State of Ohio Environmental Protection Agency

Re: Fulton County
Fulton County Landfill
Industrial Waste

May 4, 2010

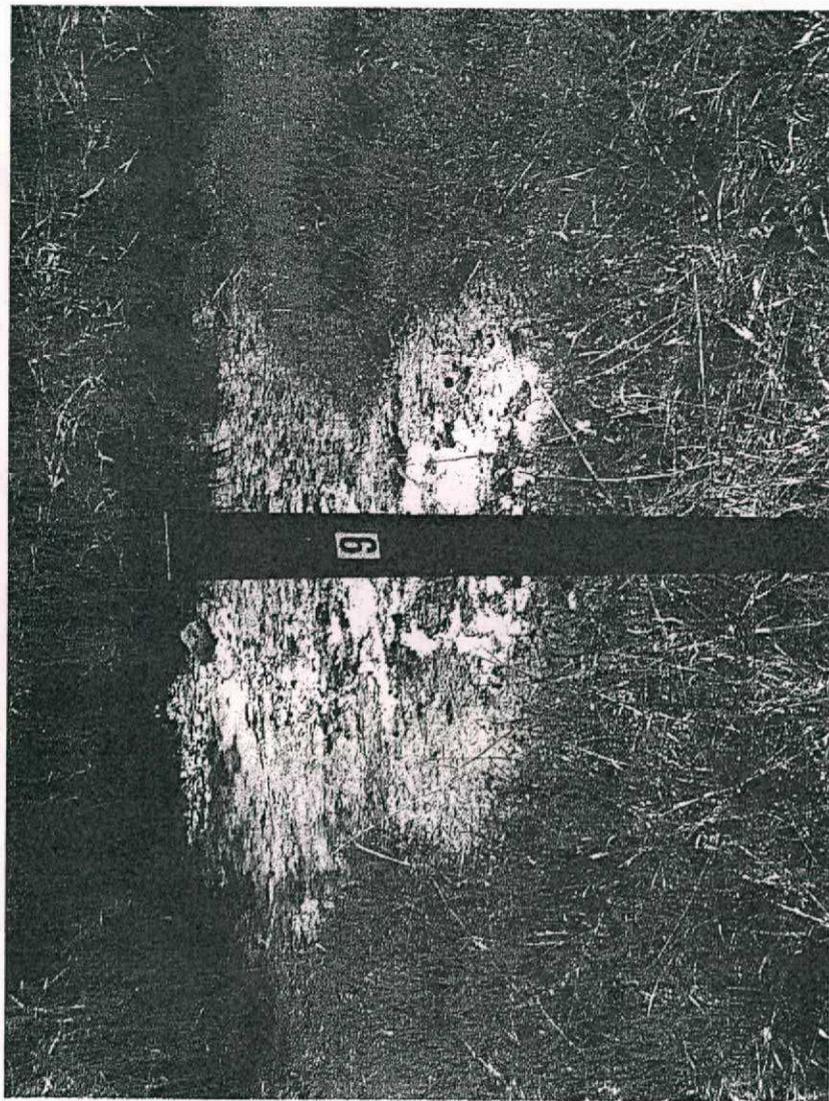
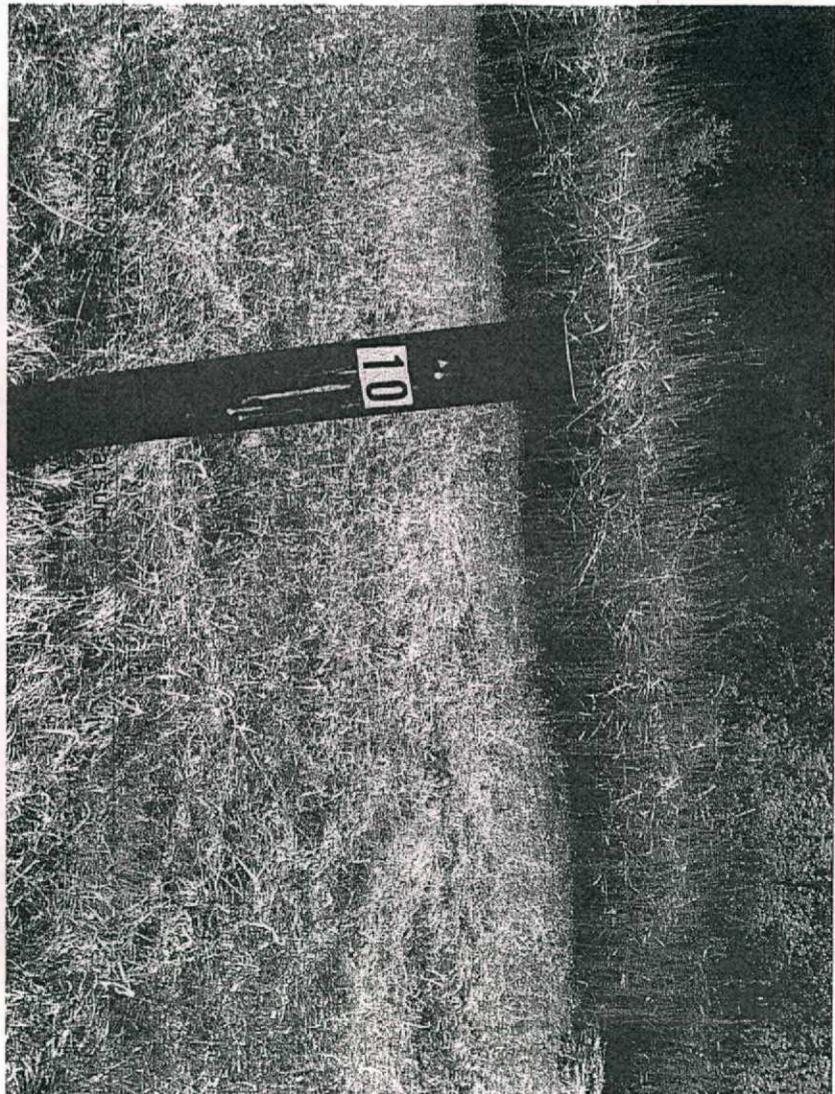
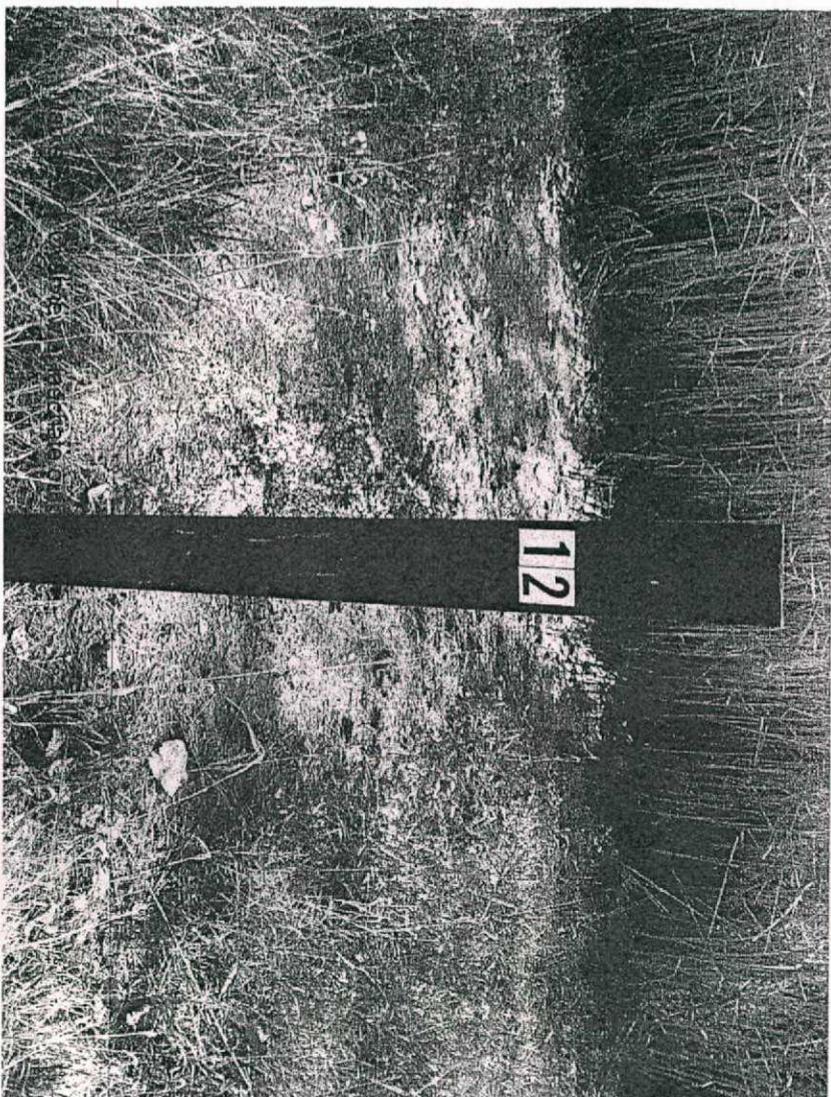
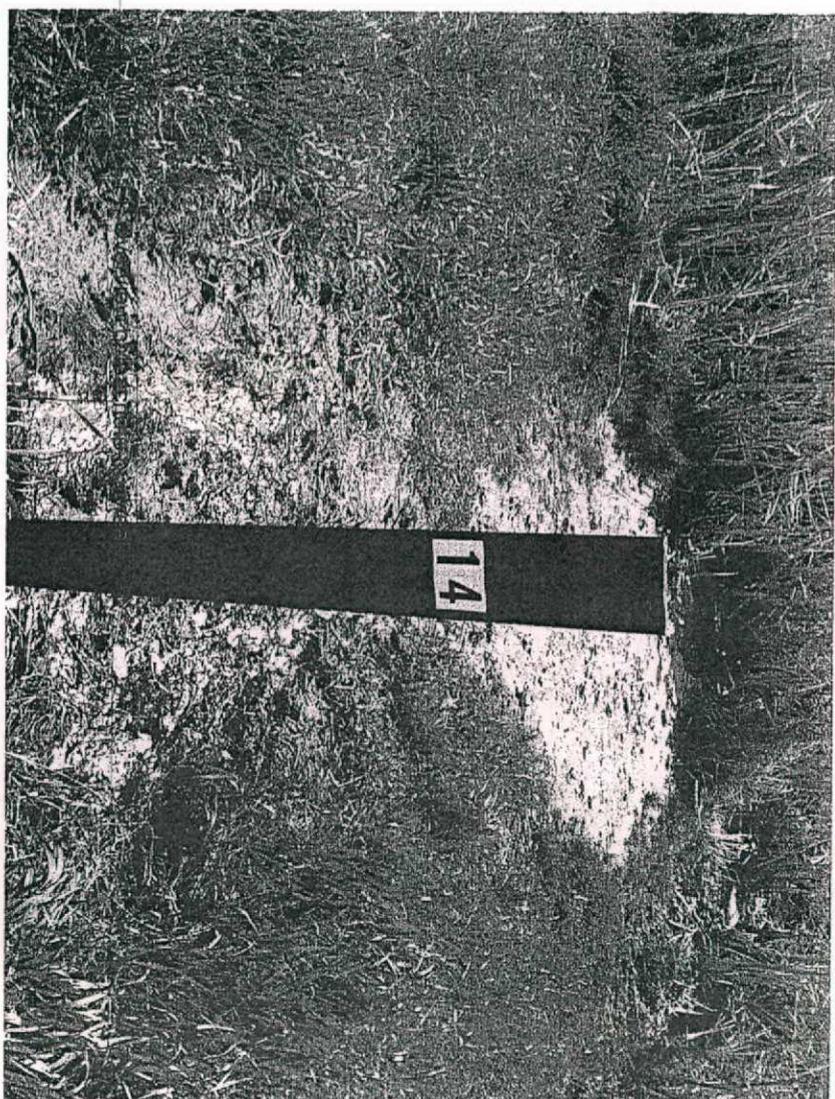
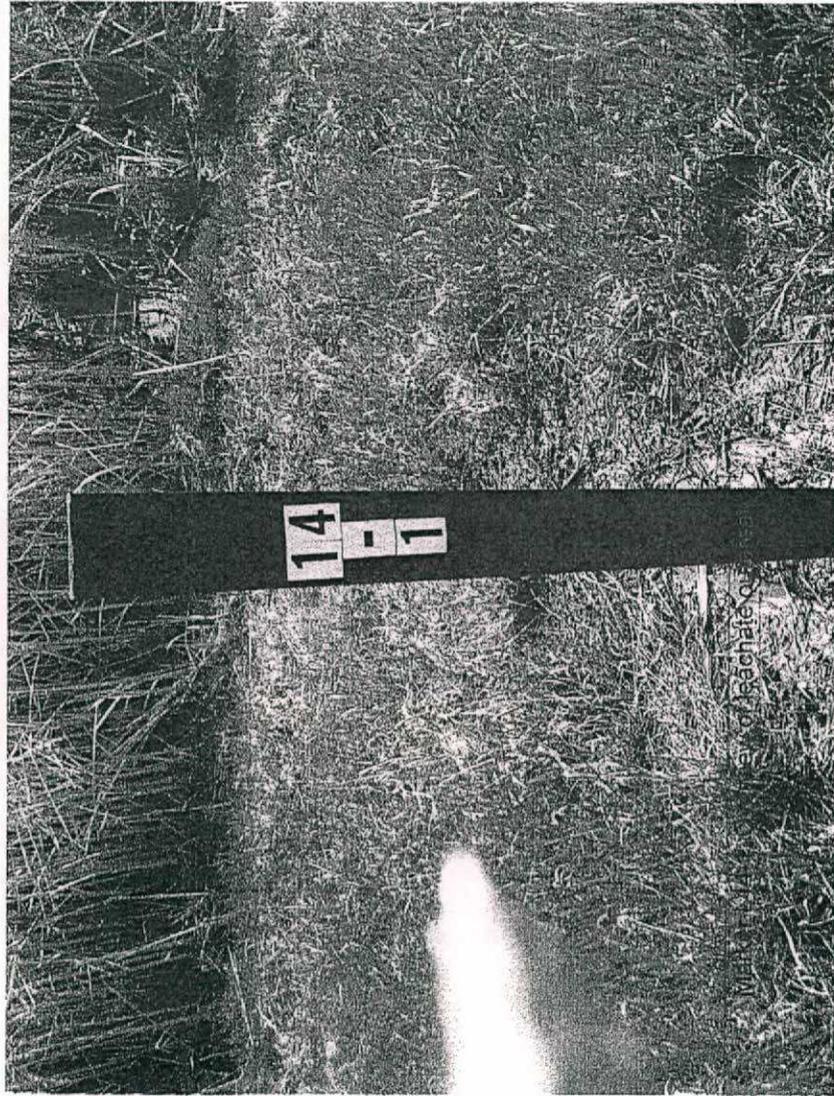
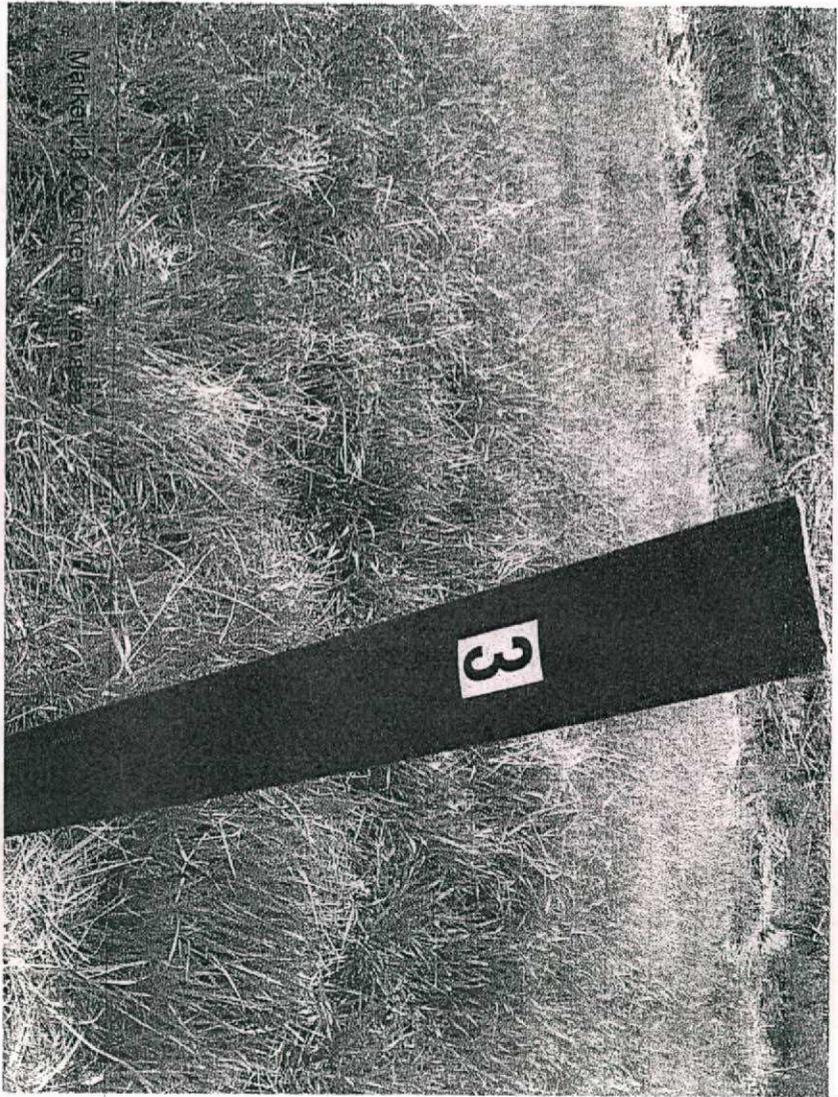
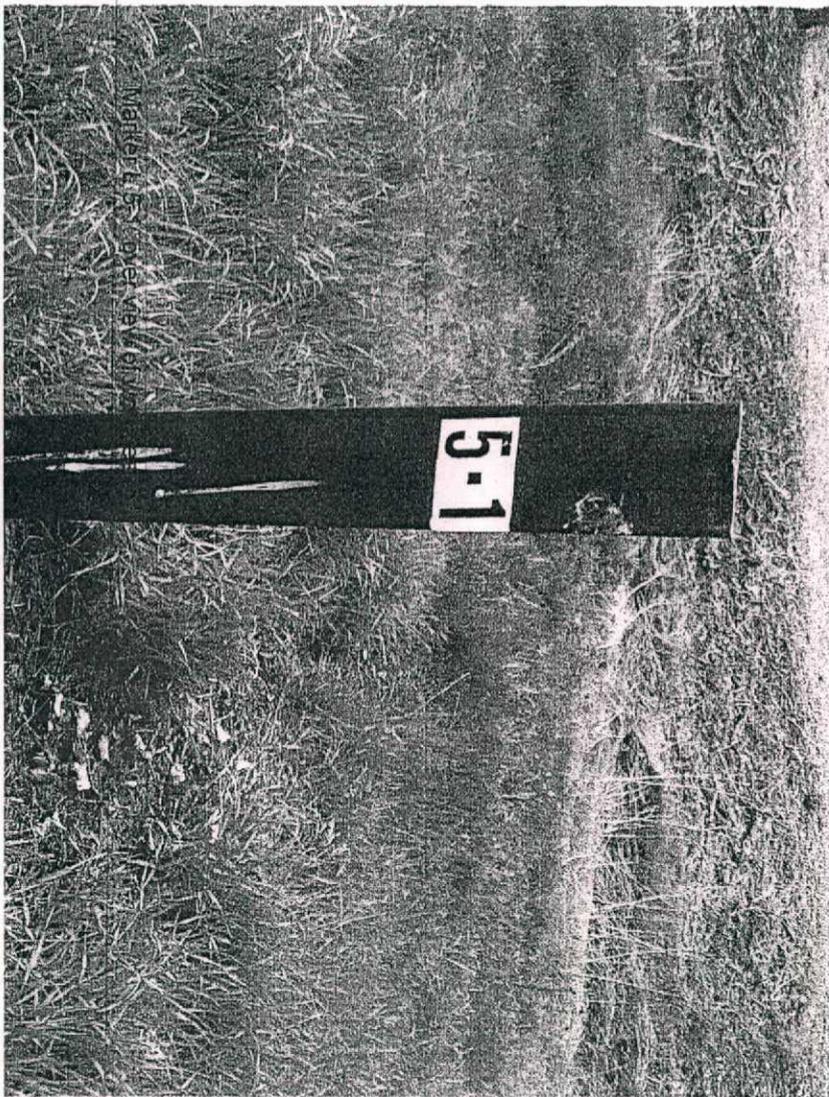
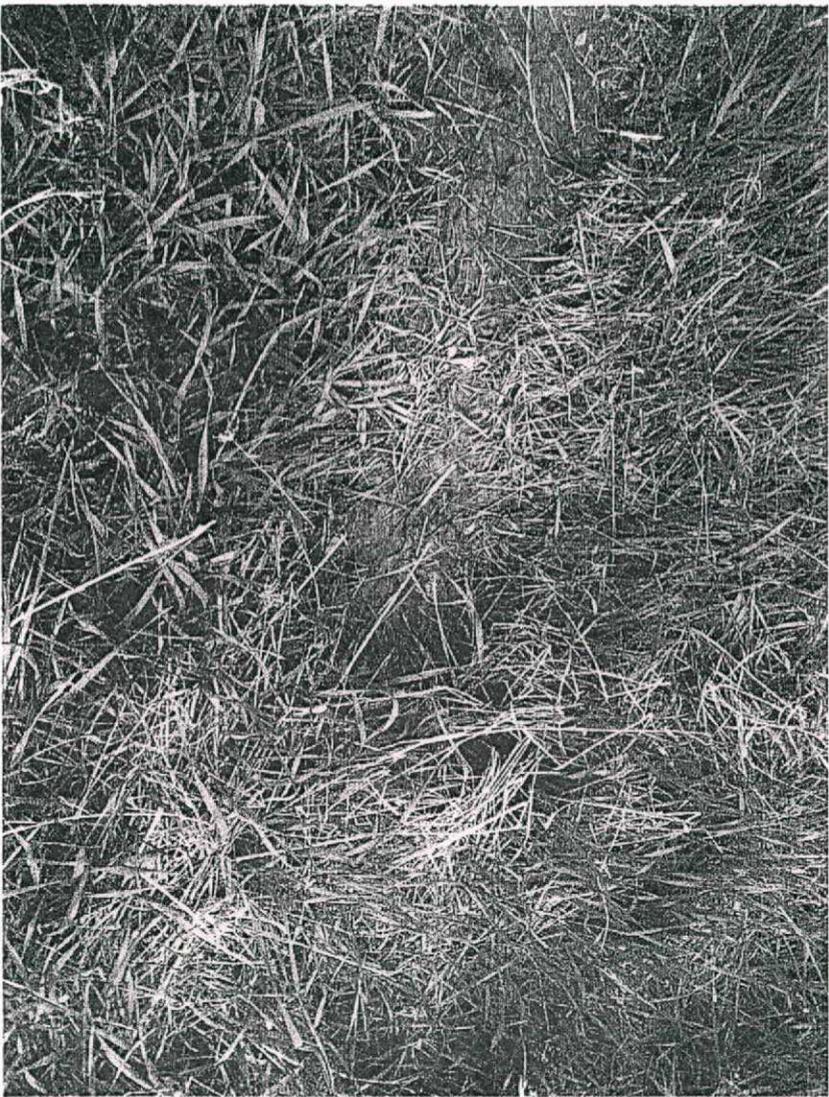
On April 29, 2010, Mr. Ryan Gierhart of Ohio EPA conducted an inspection of the Fulton County Landfill and its leachate collection system. Mr. Ziad Musallam, P.E., Fulton County Sanitary Engineer, was present during the inspection. The area around markers L-9, L-10, L-12, L-14, and L-14-1 had signs of visible leachate outbreaks. The area around markers L-3 and L-5-1 were wet. The flow of leachate to Waters of the State is prohibited by Ohio Revised Code Chapter 6111.04 and the Director's Final Findings and Orders (DFFOs) issued to you on July 9, 2002.

From our observations during the inspection, it is still apparent that the leachate level is not adequately low enough in the collection well to prevent outbreaks. The County needs to continue hauling leachate from the collection well more frequently or in larger volumes to abate the outbreaks, especially after precipitation/runoff events.

Broken Pipe - Close to Pipe

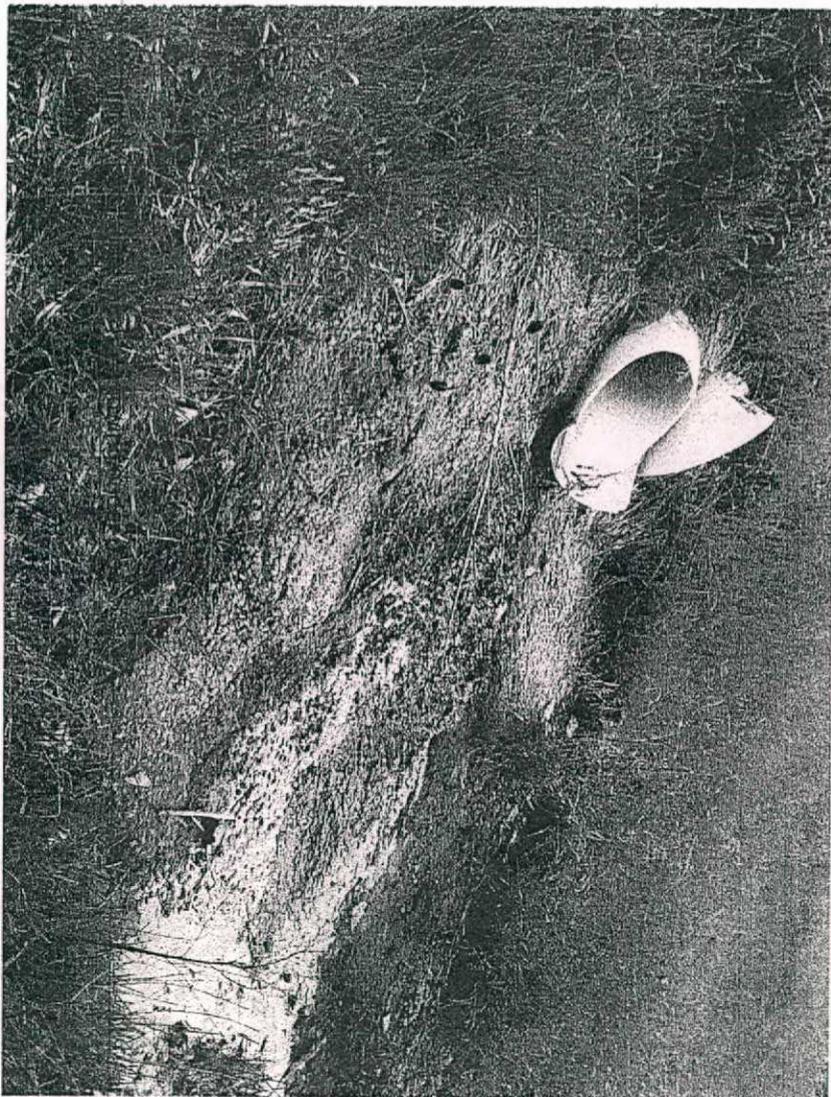
Leachate was again observed on the ground below the large, broken PVC pipe coming out of the southeast corner of the landfill. The leachate that was observed on the ground was again flowing into the ditch on the south side of the property. The ditch is considered Waters of the State and the flow of leachate to Waters of the State is an unauthorized discharge that is again prohibited by Ohio Revised Code Chapter 6111.04 and the DFFOs issued to you on July 9, 2002.
